**HARRISON COUNTY BOARD OF EDUCATION  
 HARRISON COUNTY, WEST VIRGINIA**

**BRIDGEPORT HIGH SCHOOL PRESS BOX  
 AND WEIGHT ROOM RENOVATIONS**

**ADDENDUM #2**

**THRASHER PROJECT #060-10117**

SK 1  
 A5.02

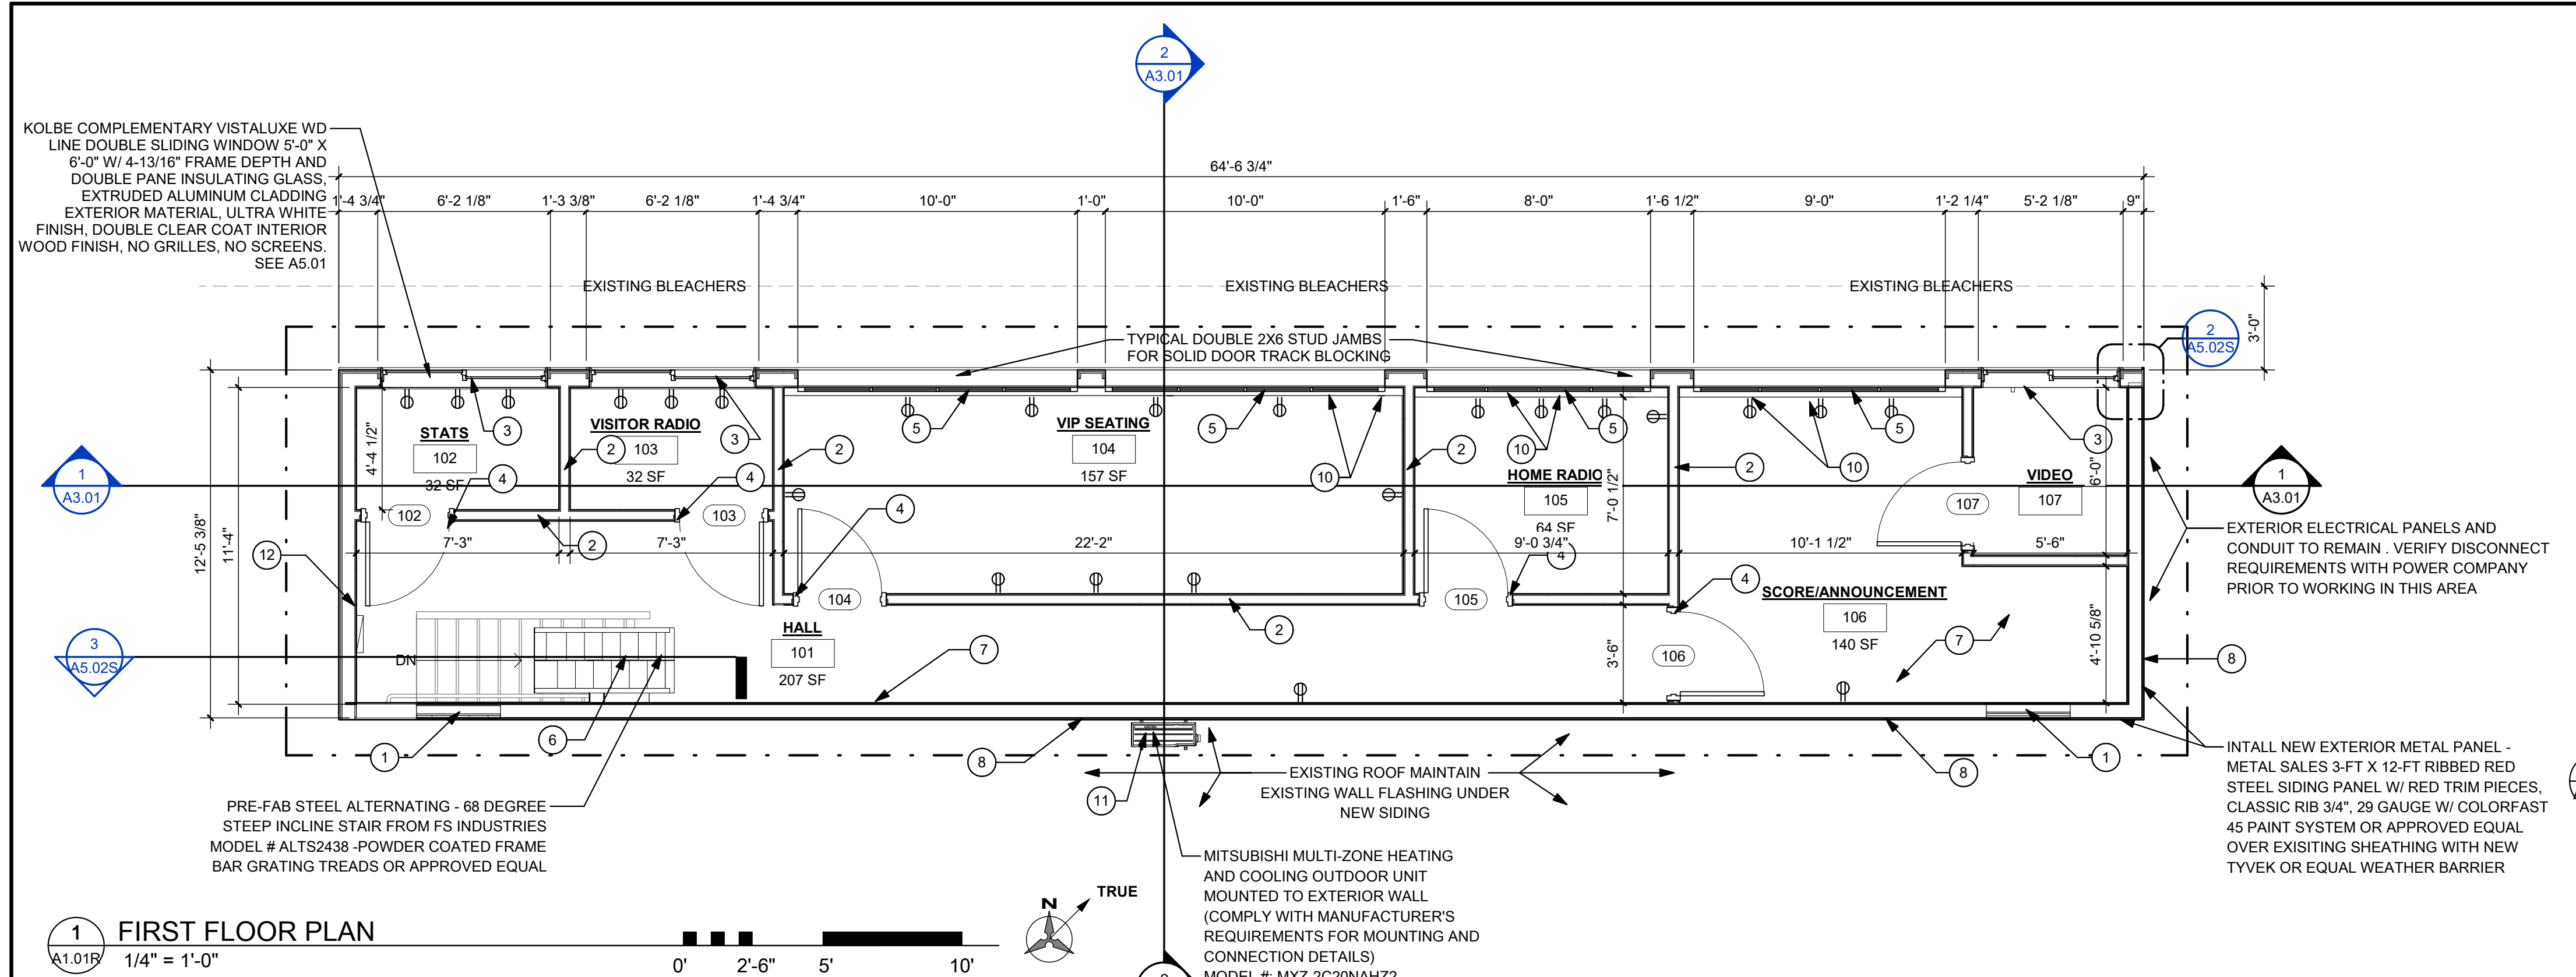
1. REVISE Demolition Note #5 to read "CARFULLY REMOVE EXISTING DOOR AND FRAME FOR REUSE. REMOVE EXISTING HARDWARE AND PREPARE DOOR FOR NEW HARDWARE."
2. REPLACE A1.01 with A1.01R
3. REVISE note "NEW WHITE PAINTED STEEL ROOF RAILING..." to read "NEW BLACK PAINTED STEEL ROOF RAILING..."
4. REVISE note "BARLISLE OR EQUAL PRODUCT..." to read "CARLISLE OR EQUAL PRODUCT"
5. ADD note on 2/A1.02 on east and west sides of the building to include "2x10 OUTRIGGERS @ 24" O.C."
6. ADD SK1/A1.02 CAMERA MOUNT DETAIL

1 FIRST FLOOR PLAN  
A1.01R 1/4" = 1'-0"

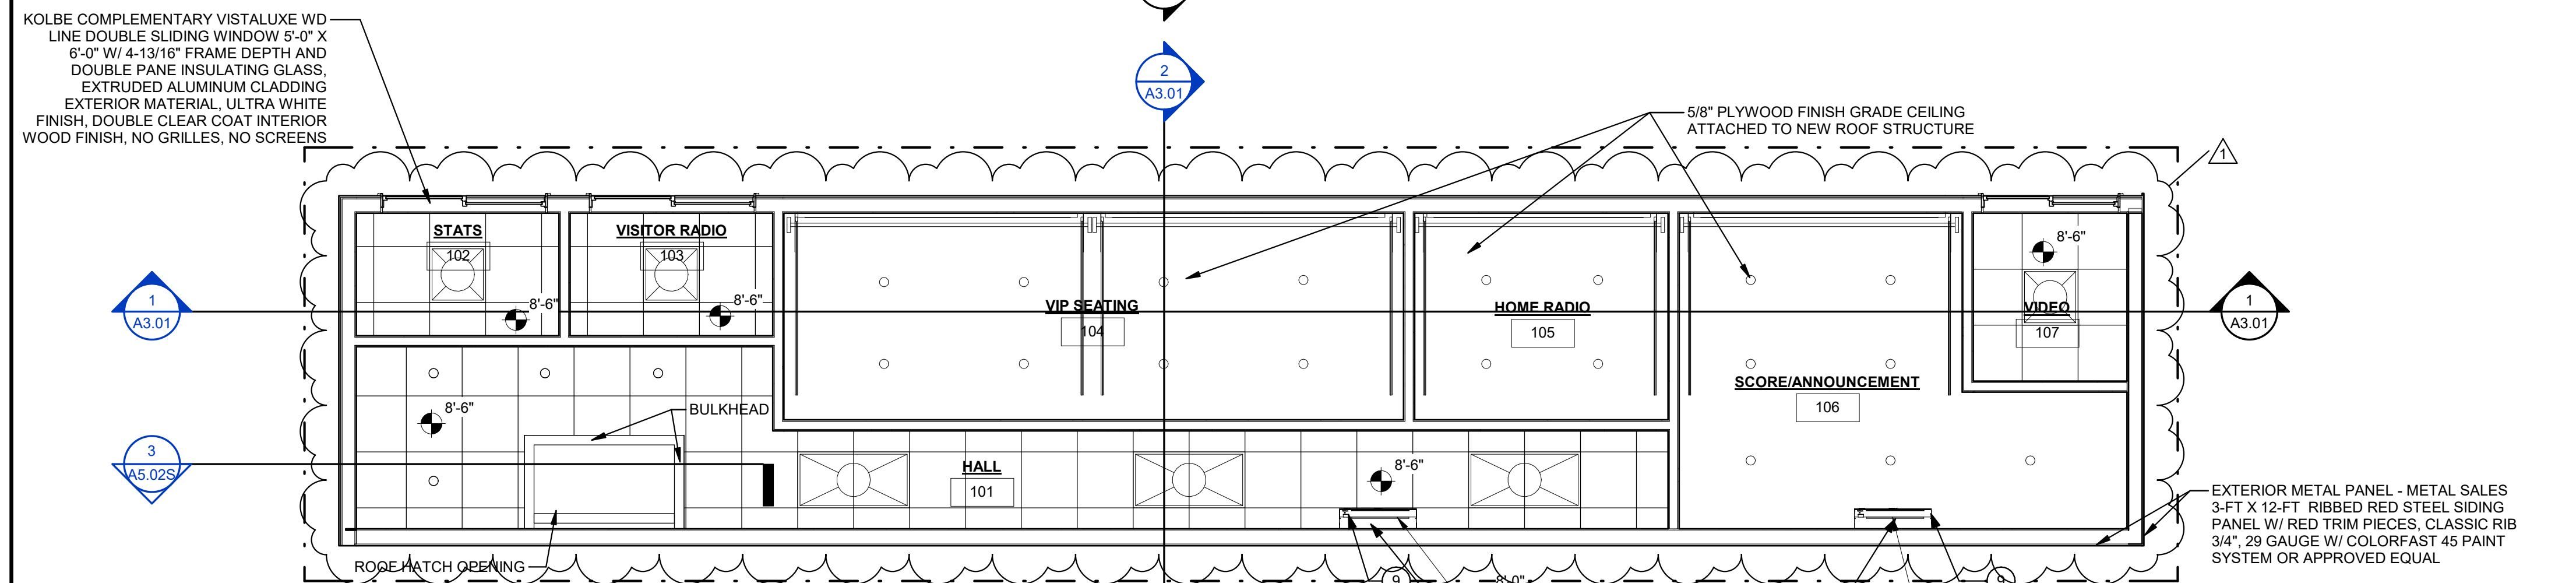
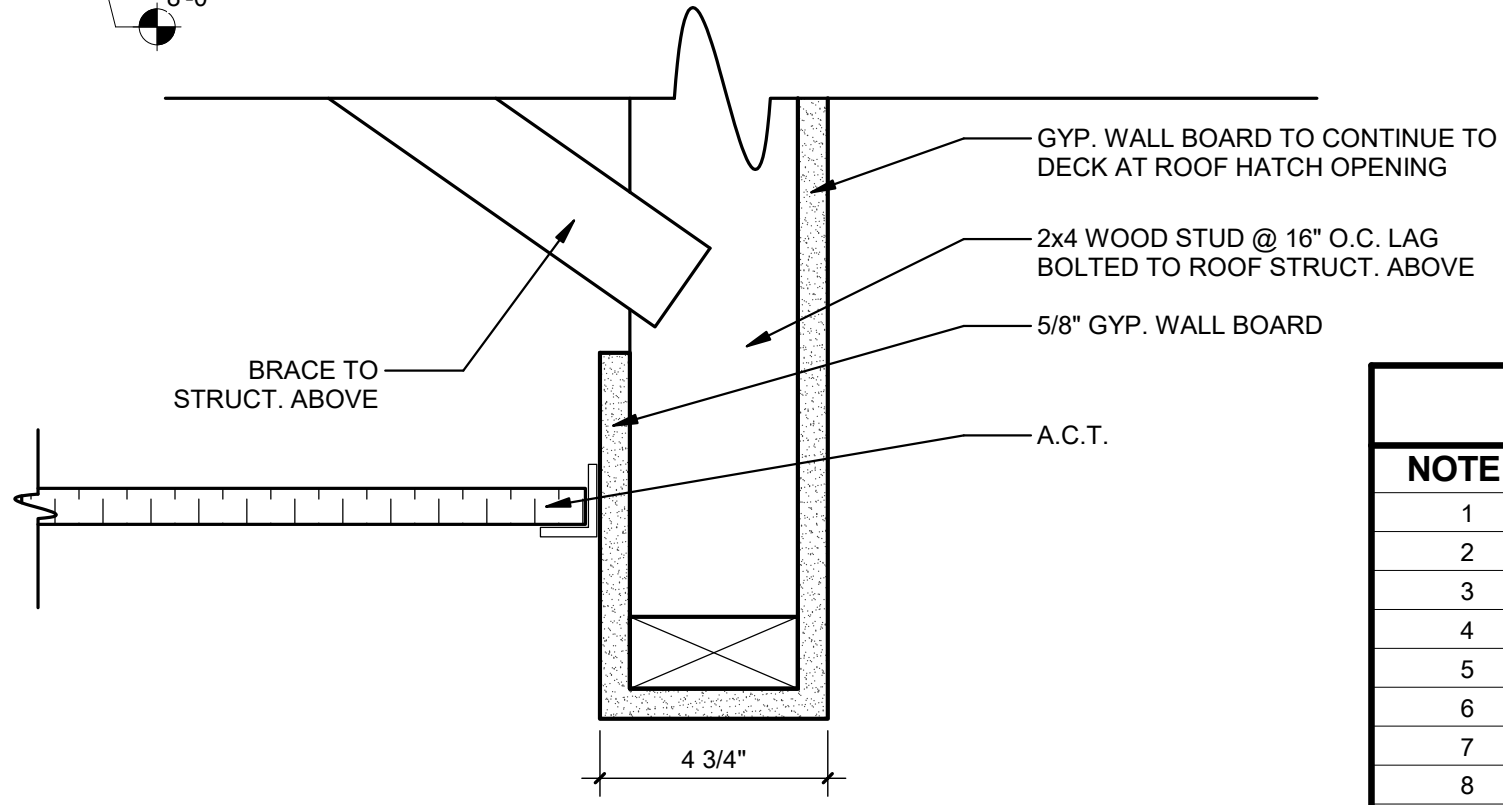
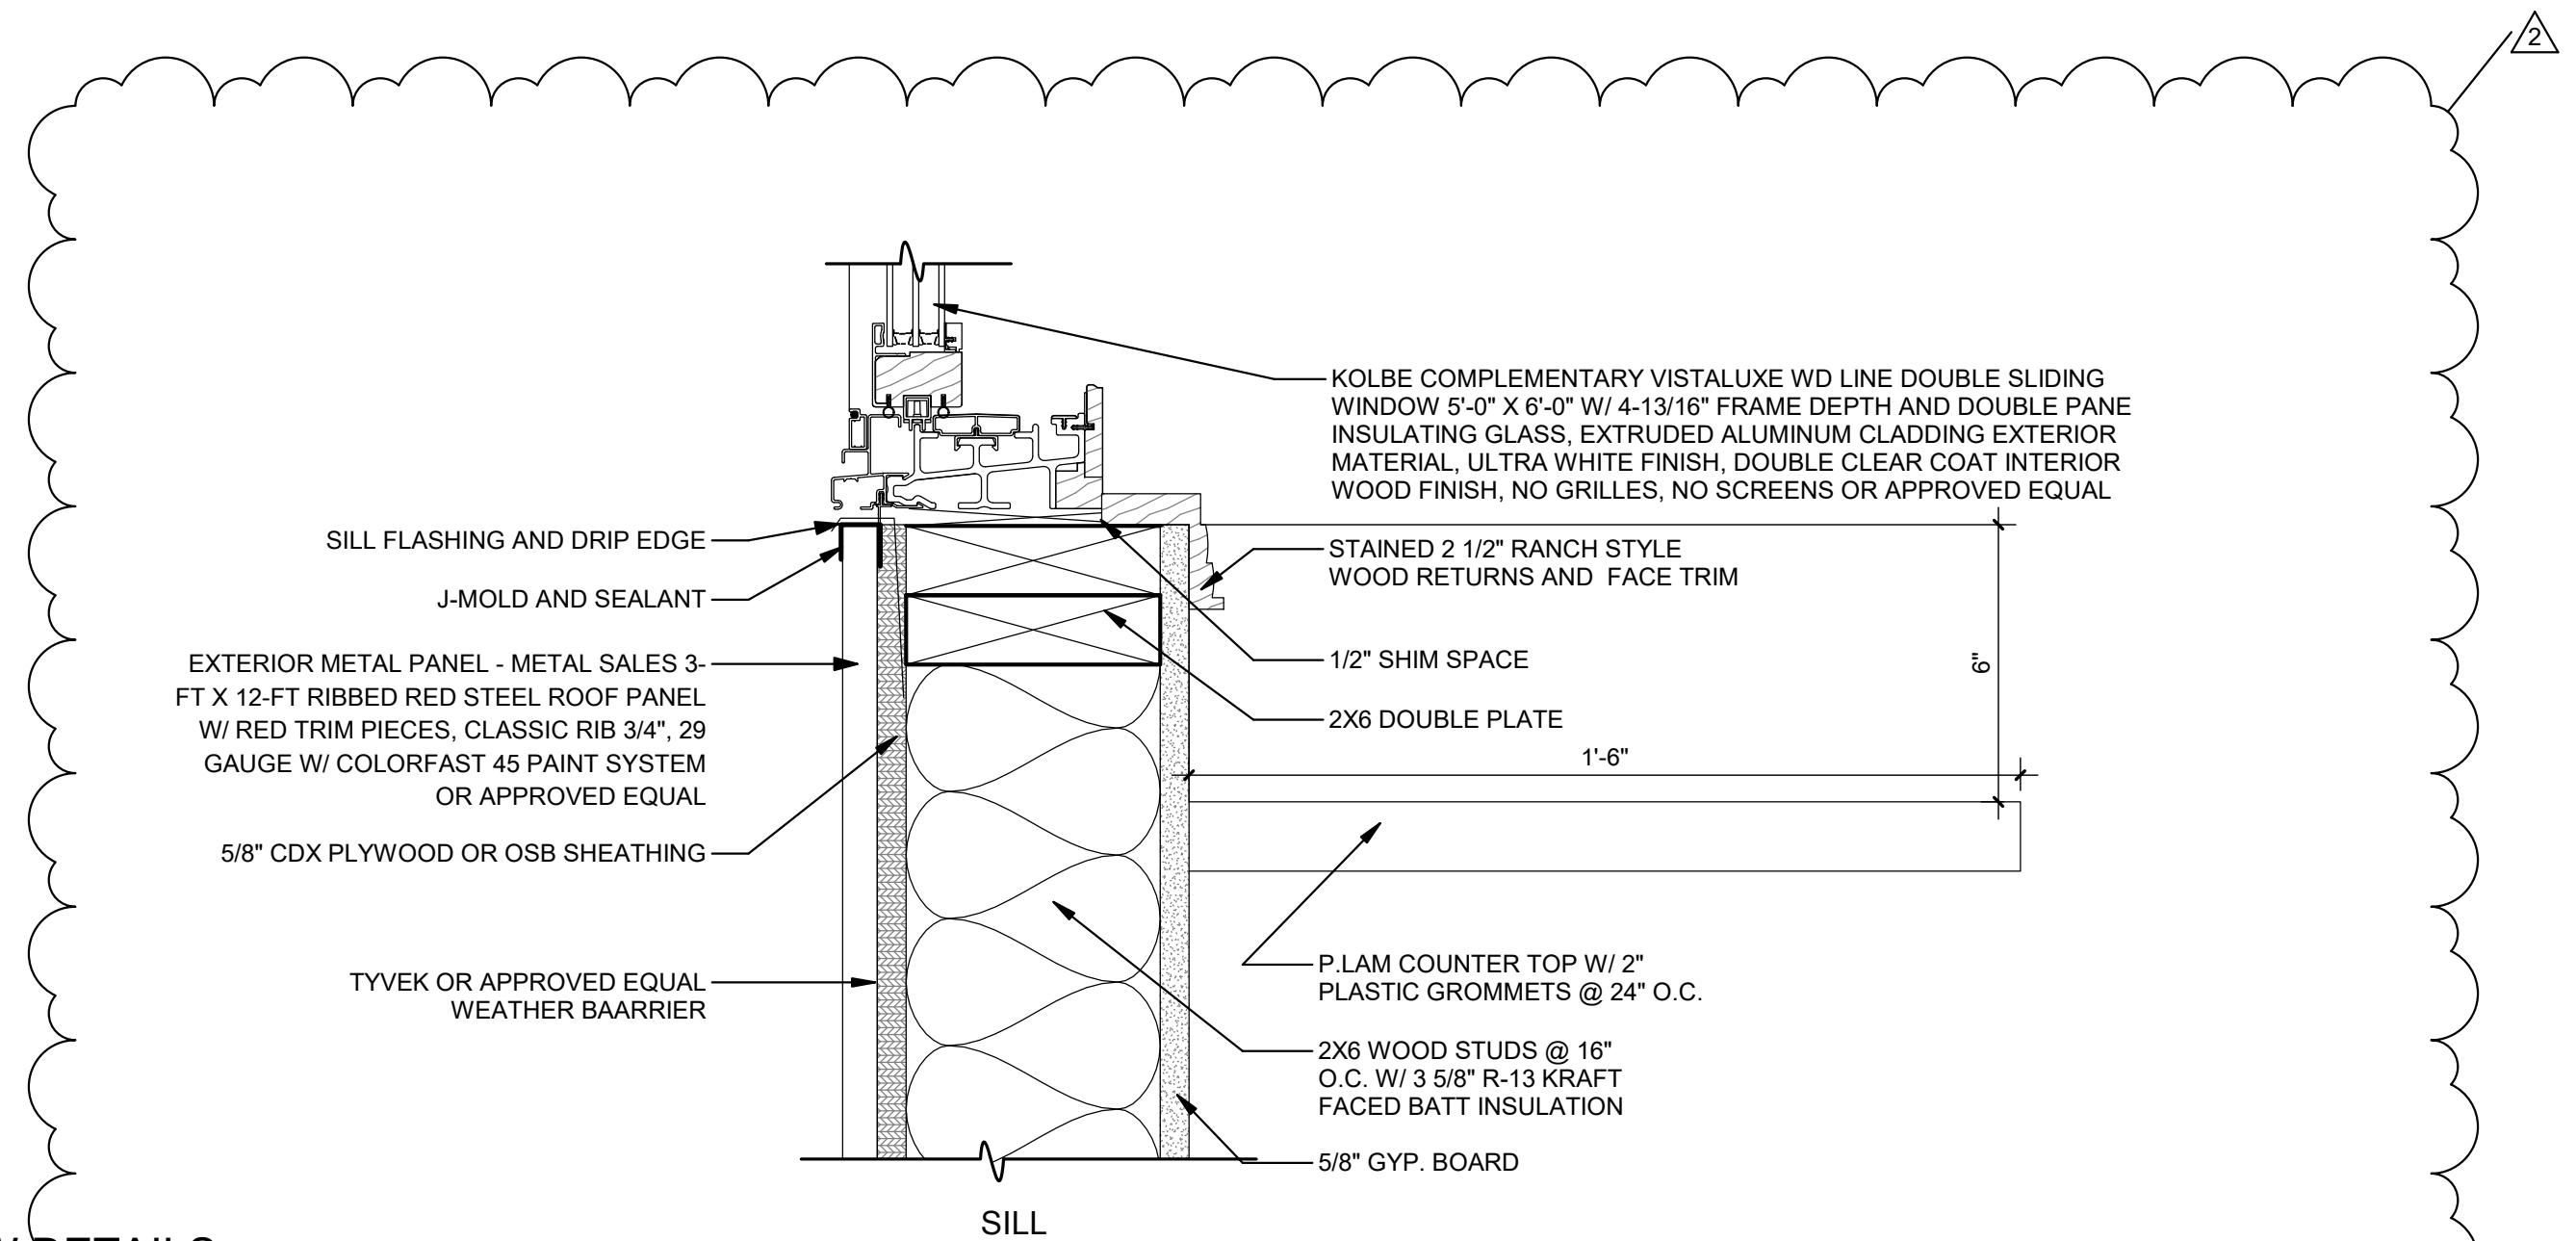
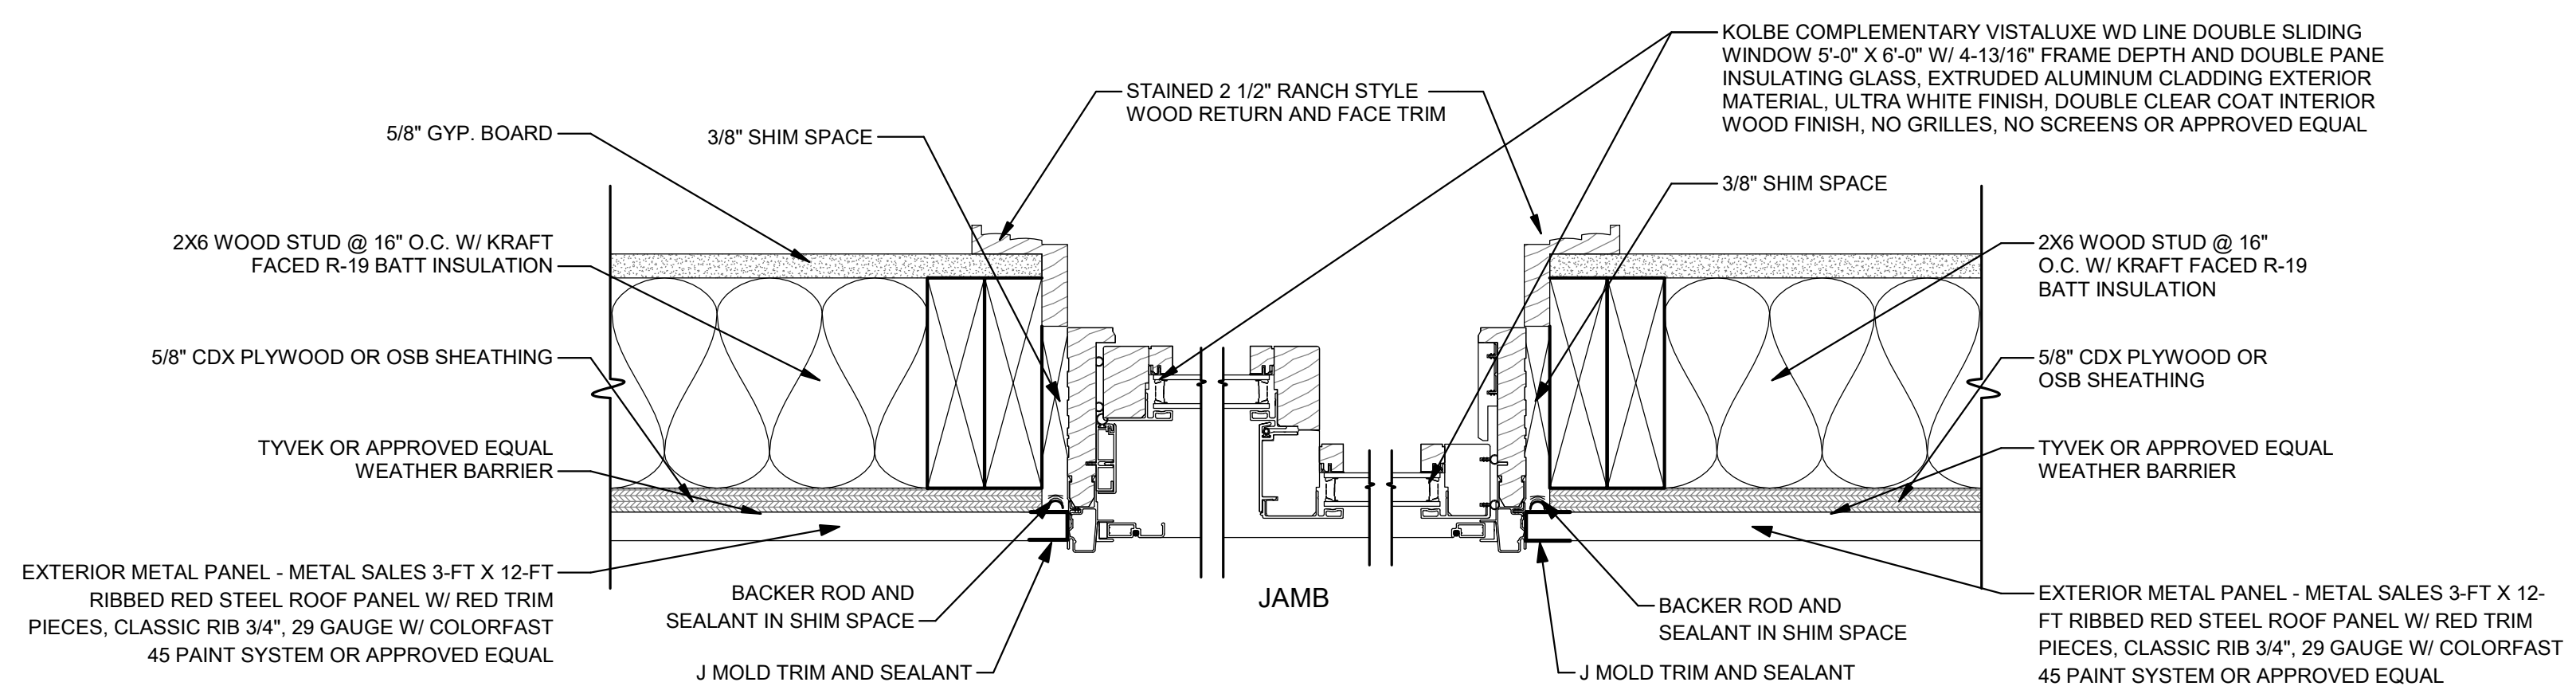
7. On A1.01 the details for the new walls in the press box show a wood framed wall, however in the general notes it calls out all new walls are to be metal framed. Which way should we figure these?

All new walls on the press box are to be wood framed walls.
